737

Service Bulletin

Number: 737-28A1206
Original Issue: January 11, 2006
Revision 2: May 21, 2009
ATA System: 2822 3152

SUBJECT: FUEL - Distribution - Center Fuel Tank Boost Pump Auto Shutoff and Master Caution Logic Change

FIGURE 1: J4 JUNCTION BOX - REMOVAL AND SALVAGE

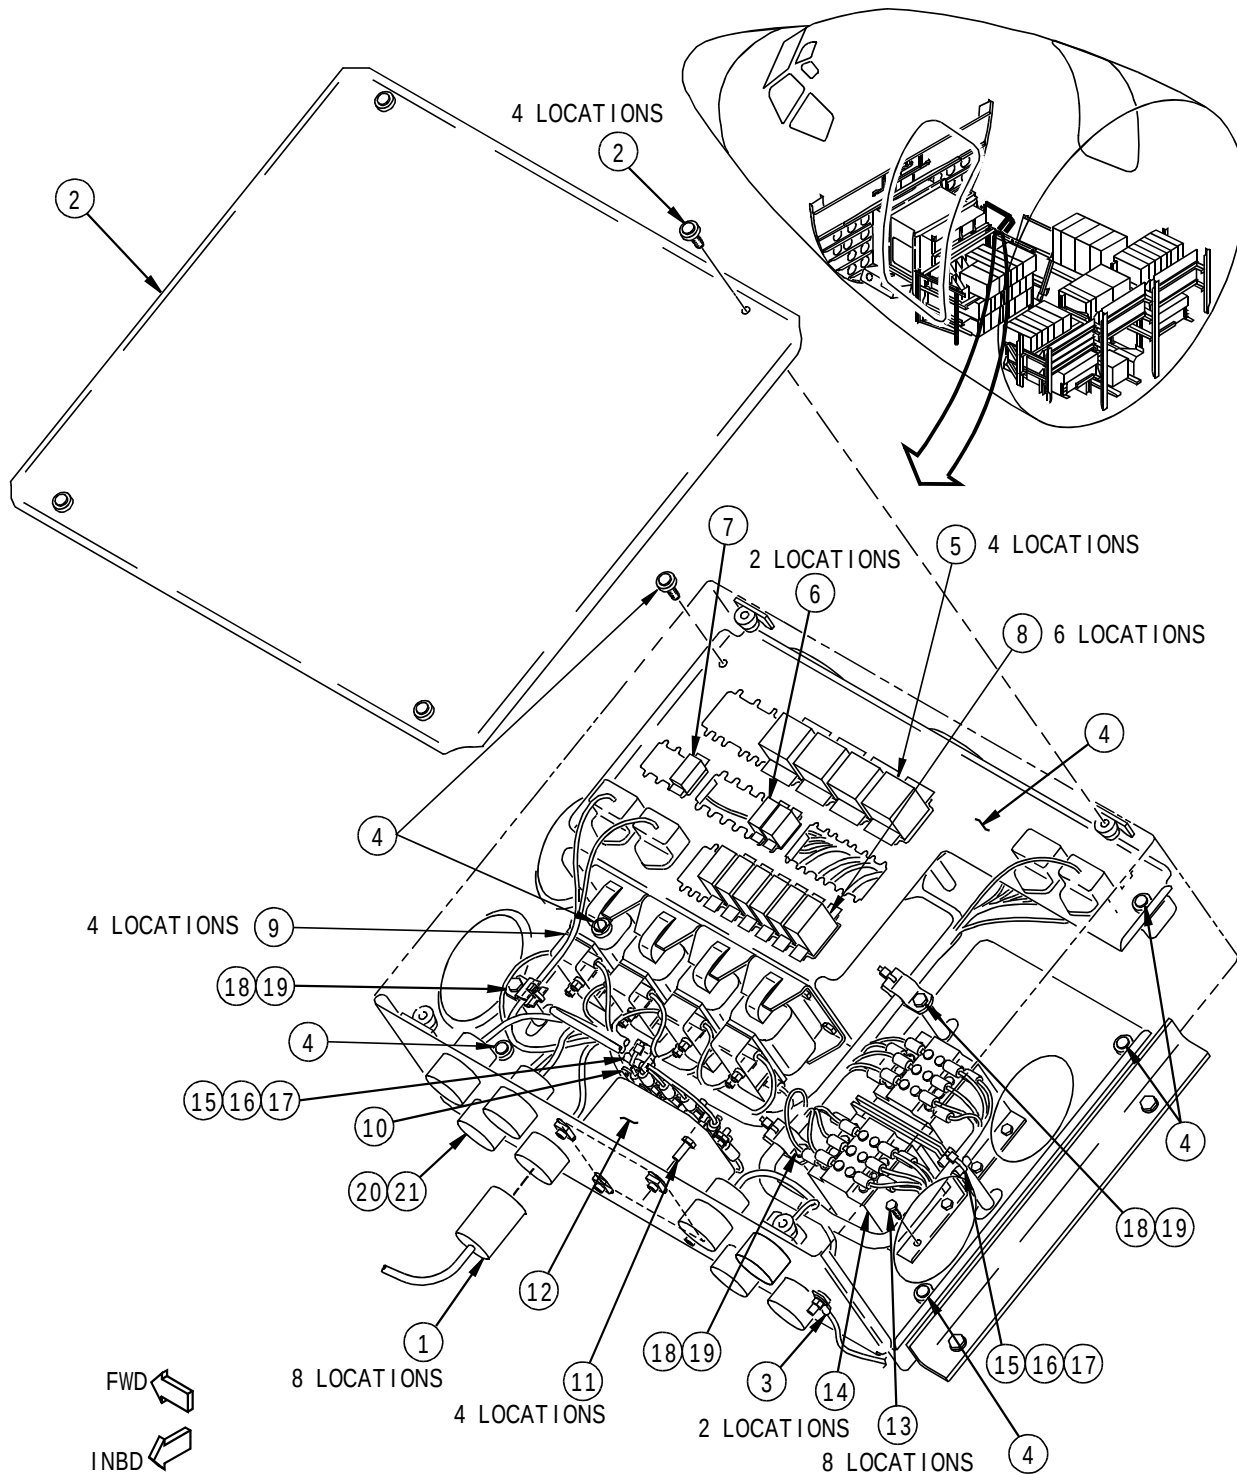
Changes are made to Figure 1 to add a new Step 1 to disconnect all the connectors from the J4 junction box and all the remaining Steps are re-sequenced. Note (a) is added to clarify the J4 junction box bottom assembly is discarded after all the parts are removed.

FIGURE 2: J4 JUNCTION BOX BOTTOM ASSEMBLY - RELAY AND MARKER INSTALLATION

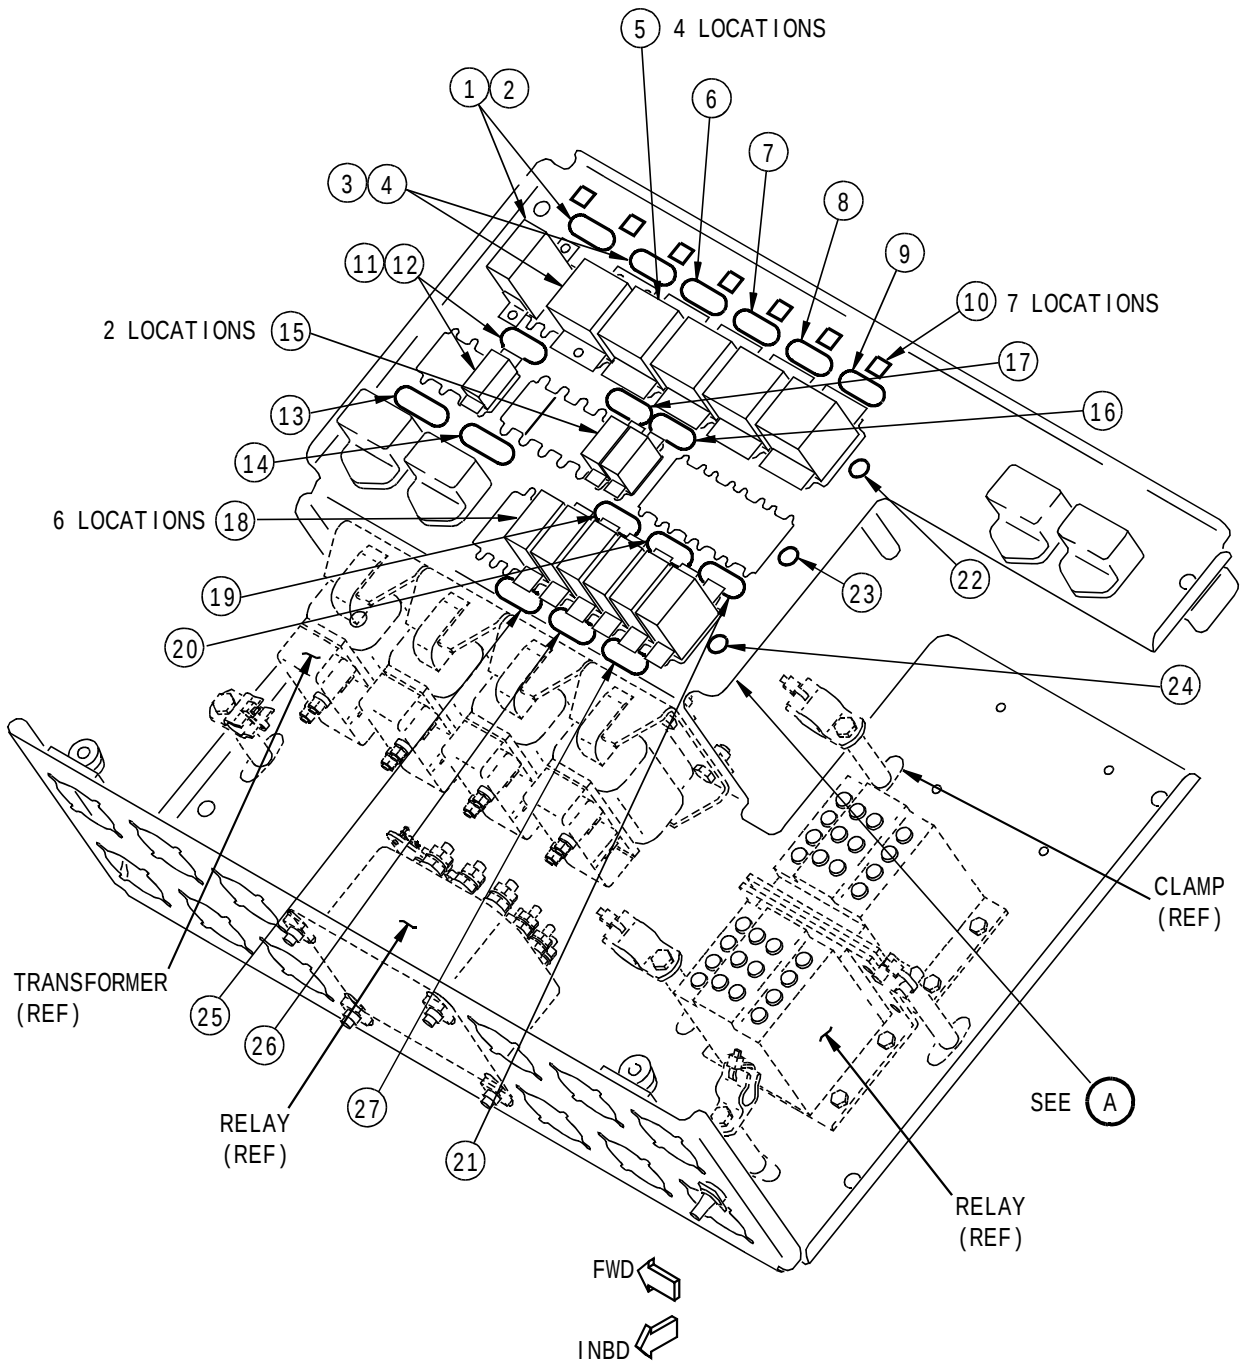
Changes are made to Figure 2 and Figure 3 to add Notes to show that the new and kept parts are fitted to the J4 junction box bottom assembly.

FIGURE 3: J4 JUNCTION BOX BOTTOM ASSEMBLY- RECEPTACLE, RELAY AND MARKER INSTALLATION

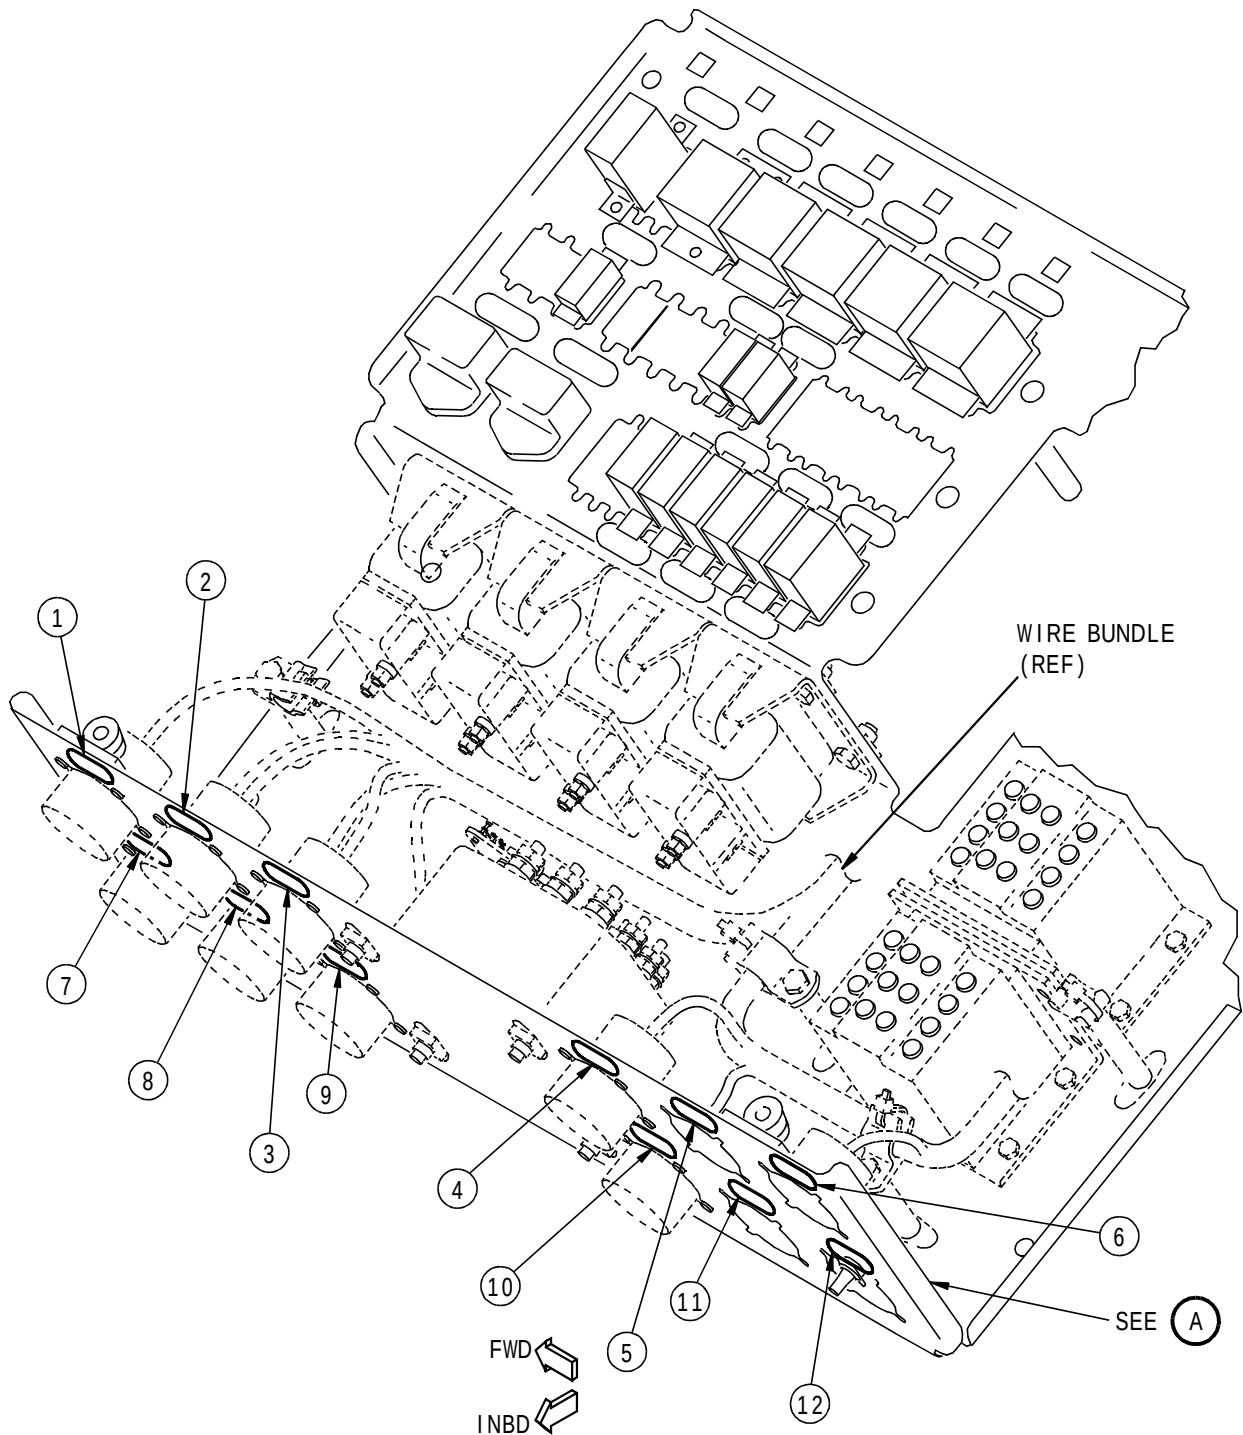
Changes are made to Figure 3 to remove the view of the new wire bundle connector.

FIGURE 4: J4 JUNCTION BOX - J4 JUNCTION BOX BOTTOM ASSEMBLY, TRANSFORMER AND MARKER INSTALLATION
(SHEET 1 OF 4)

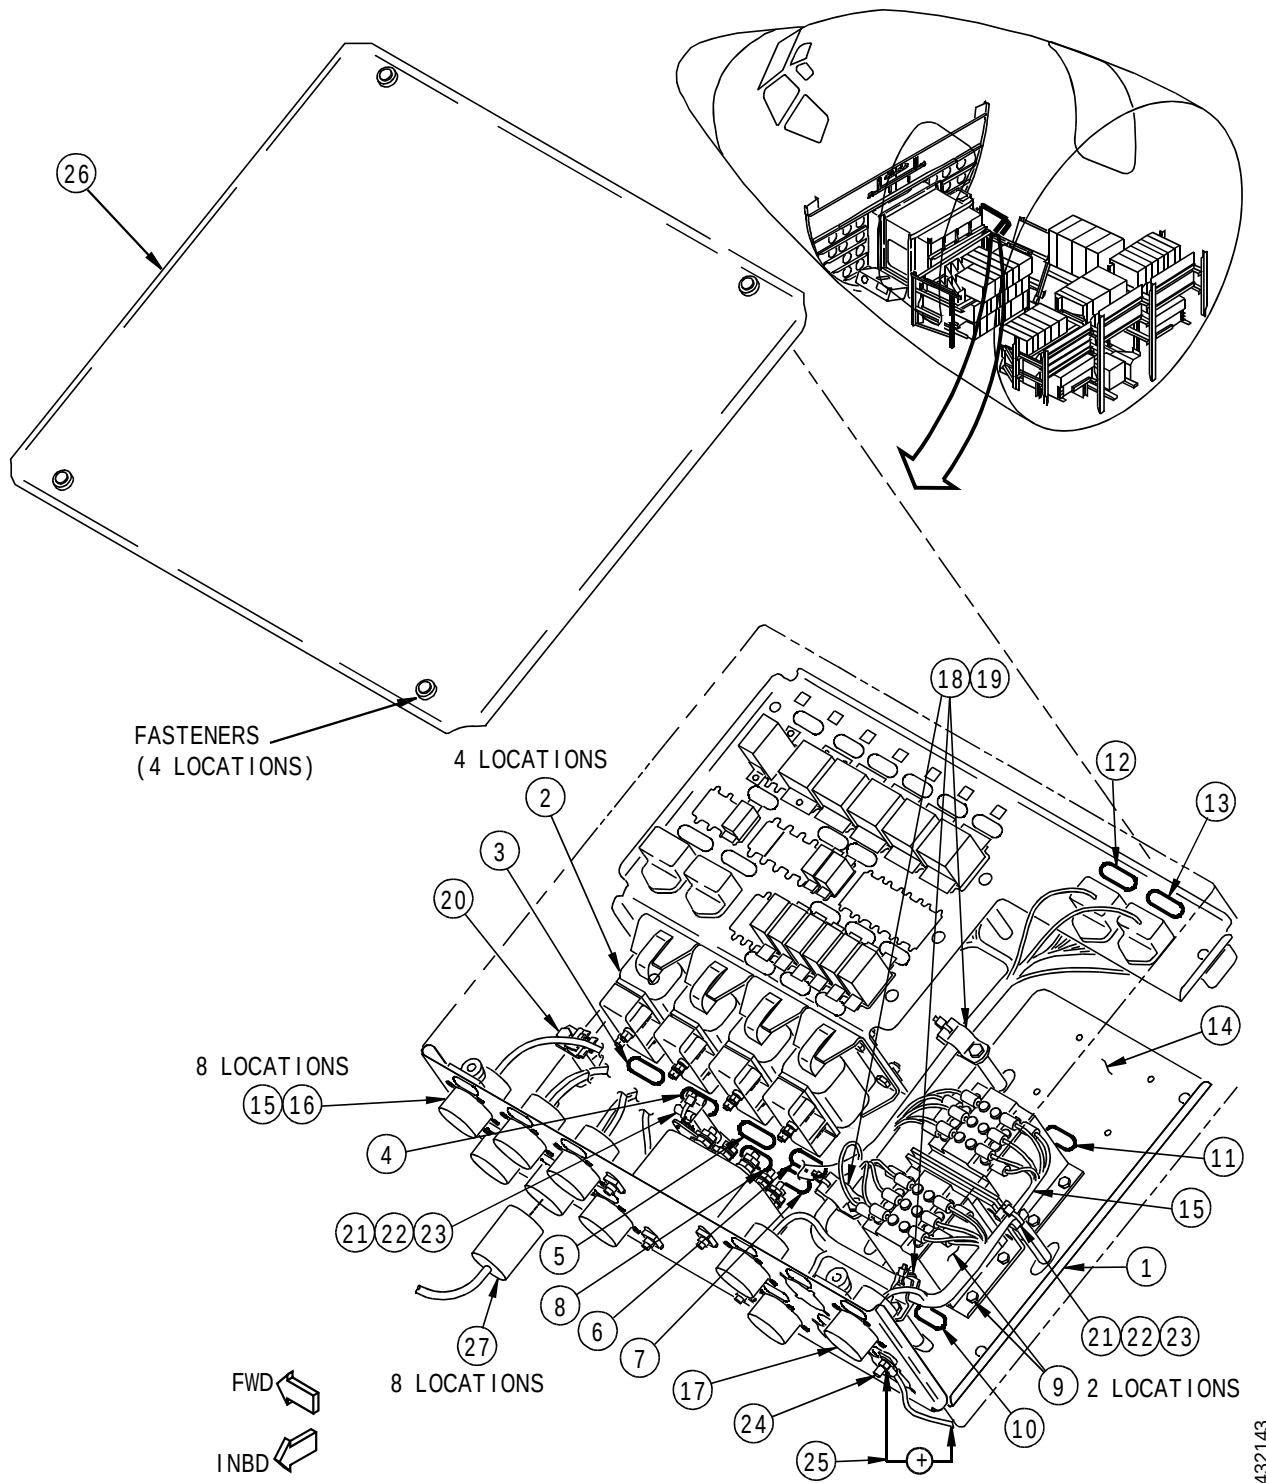
Changes are made to Figure 4 sheet 1 to show the location of the J4 junction box in the airplane. Sheet 2 is added to Figure 4 to show the location of the connectors in the J4 junction box. Changes are also made to the step table to clarify the new and kept parts.

FIGURE 6: W0094 WIRE BUNDLE ROUTING

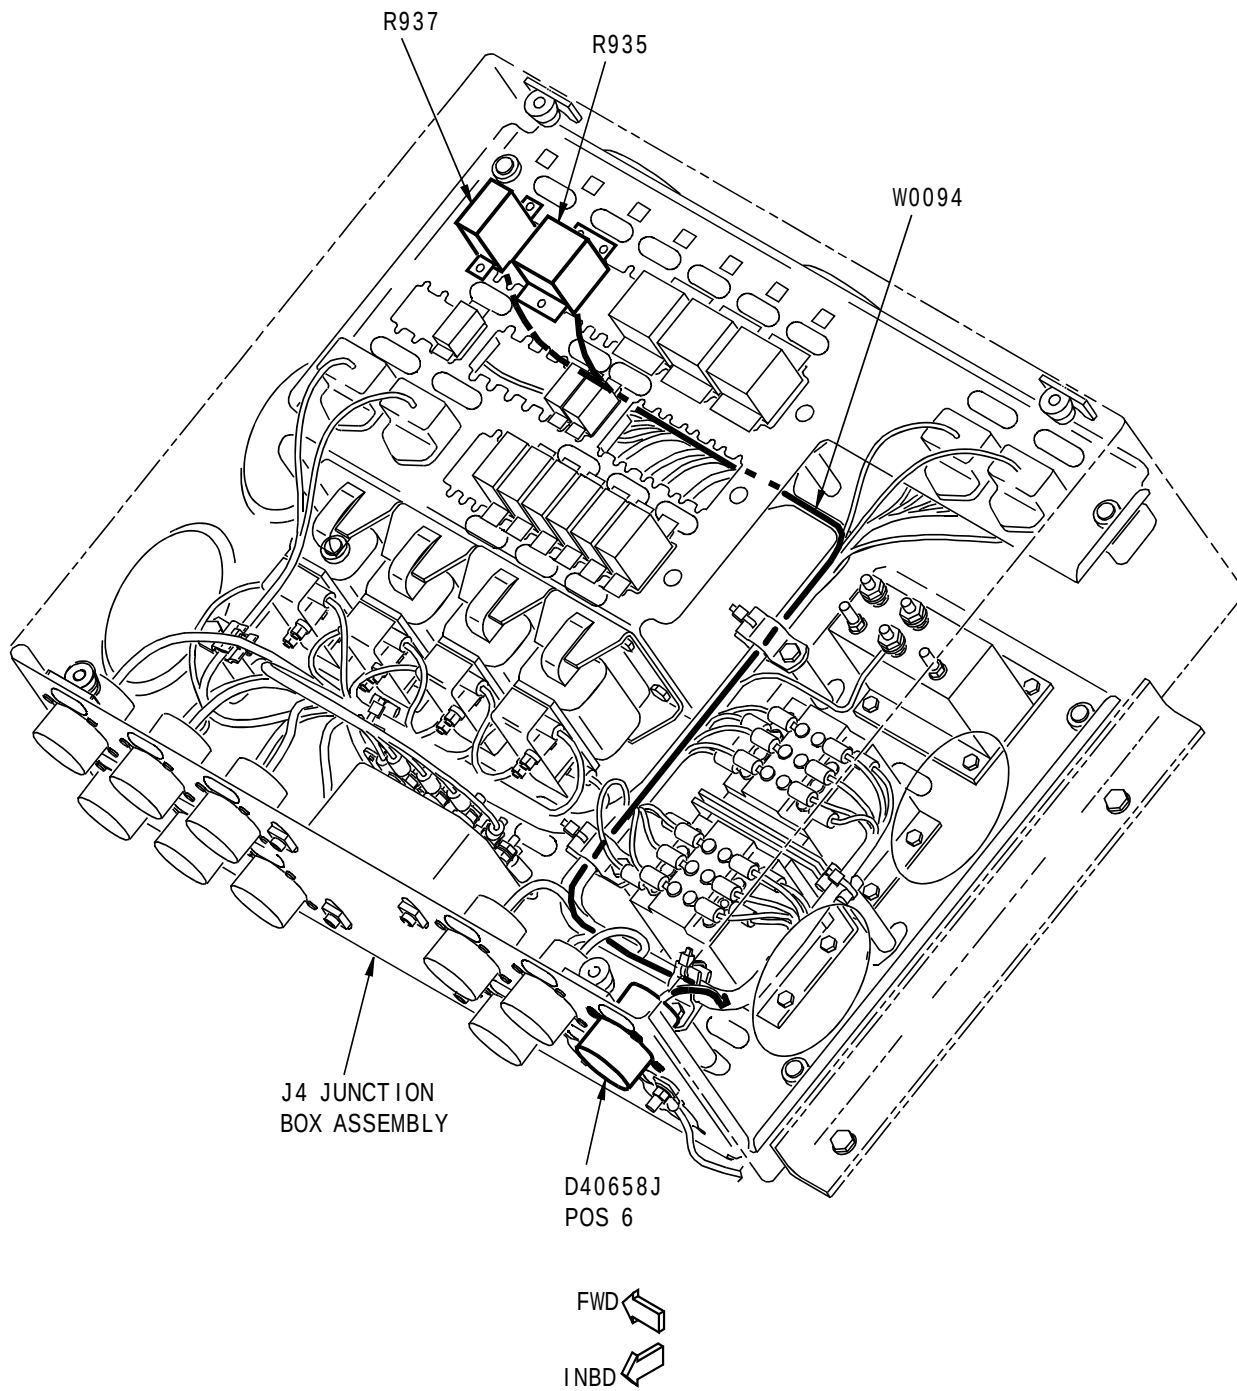
Changes are made to the applicability of Figure 6.

FIGURE 8: J4 JUNCTION BOX - MARKER AND RELAY INSTALLATION

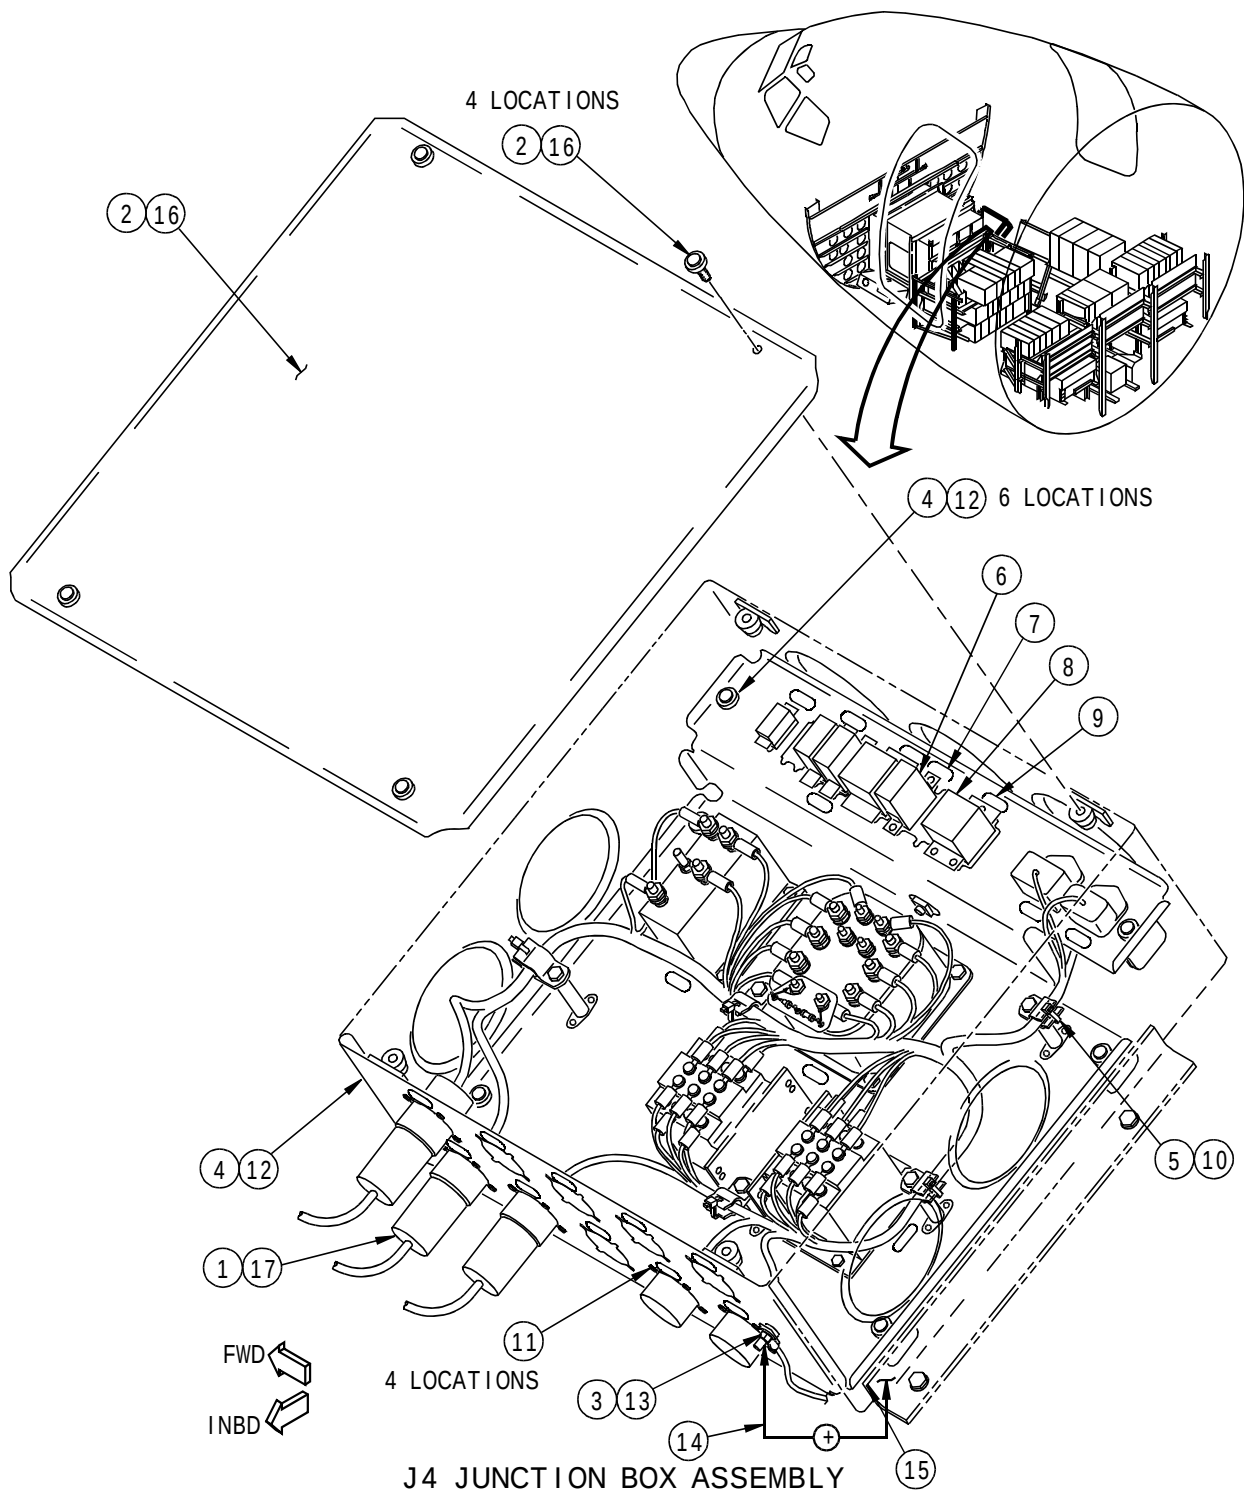
Figure 8- Changes are made to add an existing J4 Junction Box part number 284A1204-116 that was missing from previous revision, and to add the new J4 Junction Box part number 284A9200-135 that has to be marked on the re-worked J4 Junction Box 284A1204-116.

Changes are made to Figure 8 to remove the J4 junction box relay installation alternative relay configuration. Changes are also made to clarify the new and kept parts in the step table, a new Step 1 is added to disconnect all the connectors from the J4 junction box and all the remaining steps are re-sequenced.
